SERVICE CHANGE

1. Change on Crank Housing.

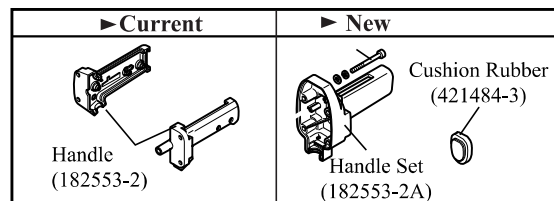
Item No.	TYPE 1	Q'ty	I/C	TYPE 2	Q'ty
032	Crank Housing 316310-8 (Discontinued)	1	No	Crank Housing 159659-1 (See Service Change 7)	1
111				Plate 50 341397-1 (See Service Change 7)	1
112				Packing 50 442009-0	1
113				Screw M5x12 911211-1	1

Note The current type crank housing and the new type crank housing are interchangeable if replaced together with the plate 50, packing 50 and screws M5x12.

2. Change on Handle Set and Cushion Rubber.

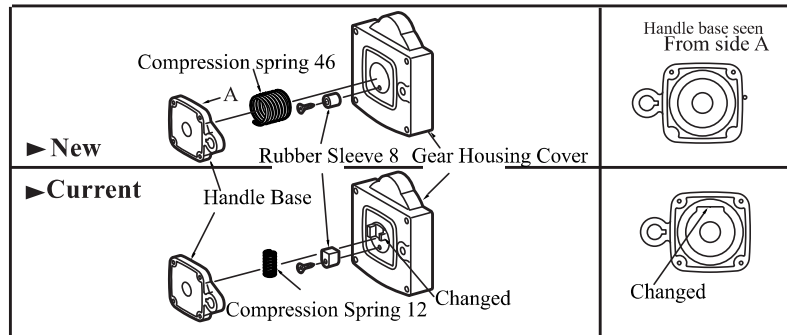
Item No.	TYPE 1	Q'ty	I/C	TYPE 2	Q'ty
93 104	Handle Set 182553-2 (Discontinued)	1	No	Handle Set 182553-2A (See Service Change 8)	1
114				Cushion Rubber 421484-3 (See Service Change 8)	1

3. Change on compression spring 46, gear housing cover, etc.

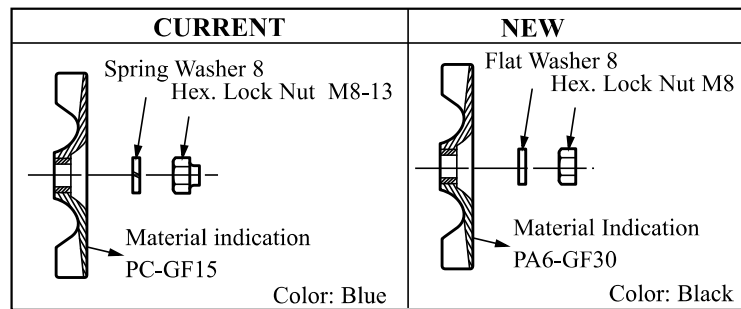
Item No.	TYPE 1	Q'ty	I/C	TYPE 2	Q'ty
95	Compression Spring 46 233051-0 (Discontinued)	1	No	Compression Spring 12 233149-3	1
52	Gear Housing Cover 316311-6 (Discontinued)	1	No	Gear Housing Cover 316792-4	1
42 94	Handle Base 322481-1 (Discontinued)	2	<=	Handle Base 324062-7	2
40	Rubber Sleeve 8 262526-2 (Discontinued)	1	No	Rubber Sleeve 8 262538-5	1

* <= mark indicates that the new type part can be substituted for the the current type part.
* The current type parts and the new type parts are interchangeable as a set of all the above parts.

4. Change of Fan100, Hex. Lock Nut M8-13 and Spring Washer 8.

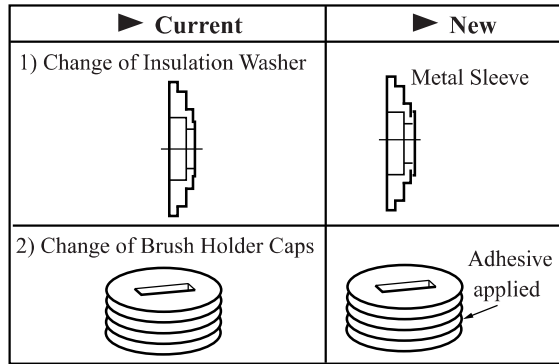
Item No.	TYPE 1	Q'ty	TYPE 2	Q'ty	I/C
013	Fan 100 241854-8 (Discontinued)	1	Fan 100 240024-6	1	<=
015	Hex.Lock Nut M8-13 252105-4	1	Hex. Nut M8 931402-8	1	<=
014	Spring Washer 8 942201-3	1	Flat Washer 8 253165-9	1	<=

Interchangeability marks; <= means that new part can be substituted for the current.

5. Change on Insulation Washer and Brush Holder Caps.

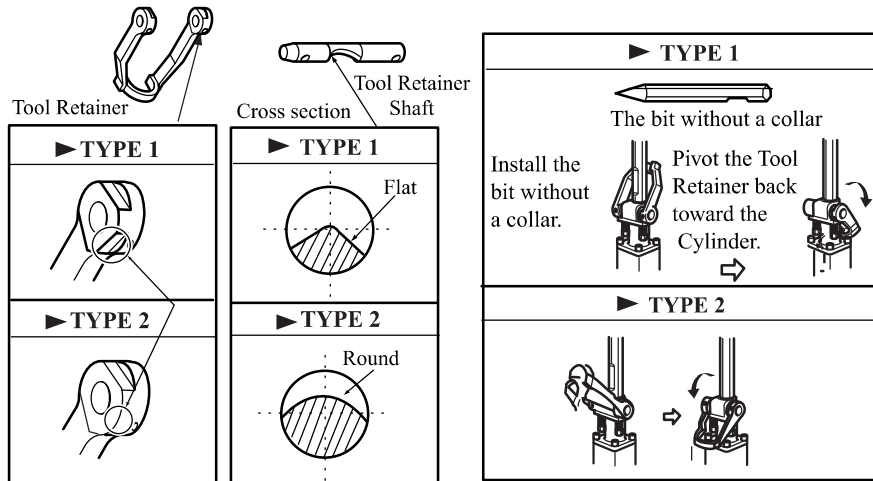
Item No.	TYPE 1	Q'ty	I/C	TYPE 2	Q'ty	Note
5	Insulation Washer 681635-2	1	<=	Insulation Washer 681646-7	1	Current parts may be used to other models
10	Brush Holder Cap 643700-5	2	<=	Brush Holder Cap 643710-2	2

The above parts are completely interchangeable as a set.

6. Change of Tool Retainer and Tool Retainer Shaft..

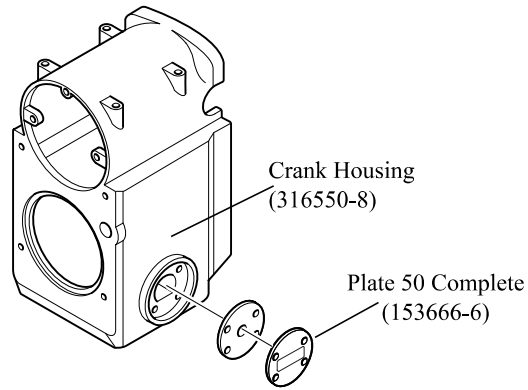
Item No.	TYPE 1	Q'ty	I/C	TYPE 2	Q'ty
078	Tool Retainer 322478-0	1	No	Tool Retainer 324236-0	1
079	Tool Retainer Shaft 322550-8	1	No	Tool Retainer Shaft 324238-6	1

7. Change on Expression and Position of Caution Label.

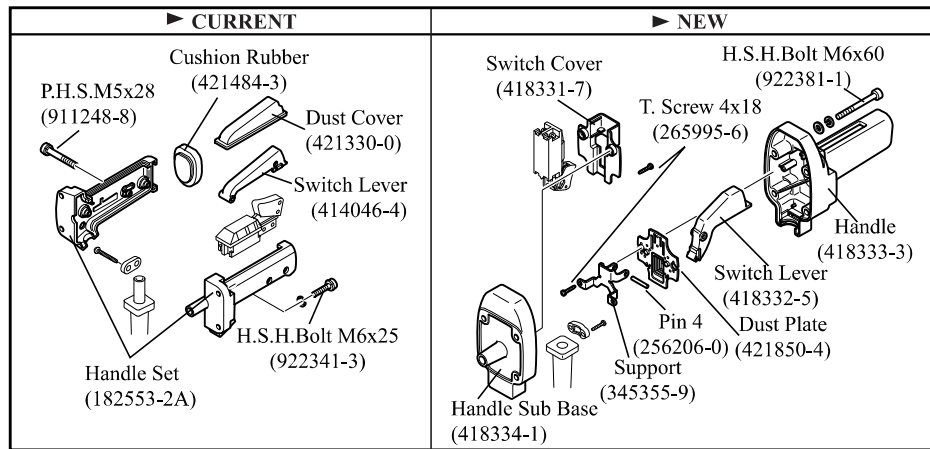
► Current	► New
<p>Caution label shown below is put on Crank Housing.</p> <div style="border: 1px solid black; padding: 5px; width: fit-content; margin: 10px auto;"> <p>NOTE: This tool contains its own grease and requires no lubrication.</p> </div>	<p>Caution label shown below is put on Plate 50.</p> <div style="border: 1px solid black; border-radius: 10px; padding: 5px; width: fit-content; margin: 10px auto;"> <p>NOTE: WE RECOMMEND YOU TO USE MAKITA'S GENUINE HAMMER GREASE. UNSUITABLE GREASE OR OIL MAY DAMAGE THE TOOL.</p> </div> <p style="text-align: center;">Pt # 817661-7</p>

Item No.	Current Part	Q'ty	I/C	New Part	Q'ty
111	Plate 50 341397-1	1	←	Plate 50 Complete 153666-6	1
032	Crank Housing Complete 159659-1 (Discontinued)	1	→	Crank Housing 316550-8	1

The arrow ← means that the new part can be substituted for the current.

The arrow → means that the new part can't be substituted for the current in a view of no caution label.
